<b>SB Number:</b>	<b>SB PF-015</b>	<b>Creation Date:</b> 05/11/2008
<b>Subject:</b>	<b>The leading edge of paper bends.</b>	
<b>Model:</b>	<b>PF-700/710</b>

Affected models: PF-700: FS-9130DN/9530DN  
: PF-710: FS-C8100DN

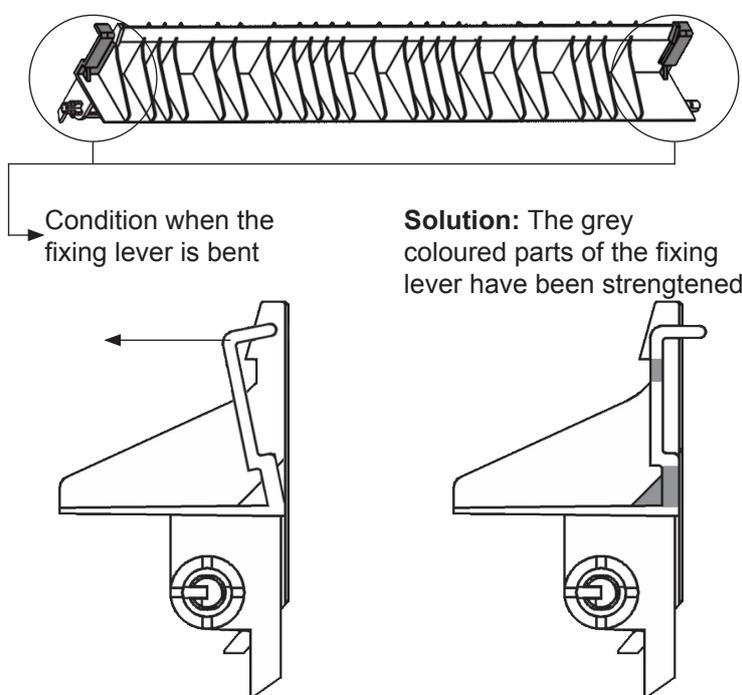
<b>Phenomenon</b>	The leading edge of paper bends.
<b>Cause</b>	The <b>fixing lever</b> of the <b>guide vertical conveying left</b> bends, and parts may brake off.
<b>Solution</b>	Parts of the <b>fixing lever</b> have been strengthened.

Grey coloured parts of the **guide vertical conveying left** (303J424011) have been strengthened.

<b>Classification</b>	<input type="checkbox"/> Entire stock rework <input type="checkbox"/> In-field modification at next visit <input checked="" type="checkbox"/> In-field modification by case <input type="checkbox"/> No modification necessary
<b>Field measure</b>	When the above mentioned phenomenon occurs, replace guide vertical conveying left 303J424010 with guide vertical conveying left 303J424011.
